Rezoning Transportation Analysis

Petition Number: 2020-038

General Location Identifier: Tax ID 20143102

Date	Description
04-22-2020	First Review
05-19-2020	Second Review
06-25-2020	Third Review

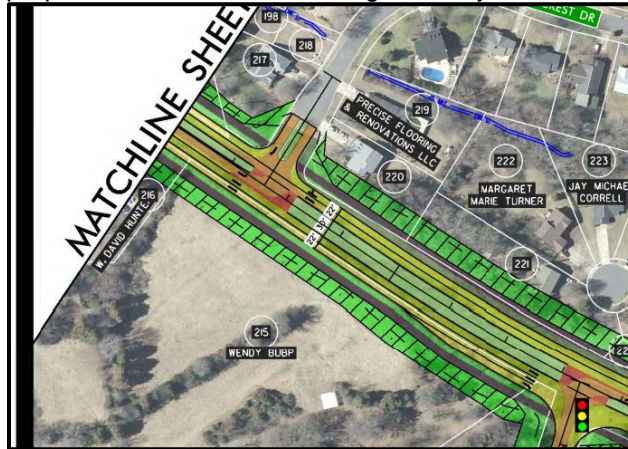
4. ~~The petitioner should revise the site plan and conditional note(s) to commit to provide a 50-foot driveway stem from the future NC 160 right-of-way line.~~
 - a. ~~**New Comment based on revised site plan dated 4-1-2020:** Please refer to the cross section below on the NC 160 project's Map 4 at <https://www.ncdot.gov/news/public-meetings/Pages/U-5766-2019-08-21.aspx>. This resource will provide more guidance to properly revise the driveway stem to provide 50' from the future right-of-way line. The driveway should be perpendicular with the future right-of-way.~~
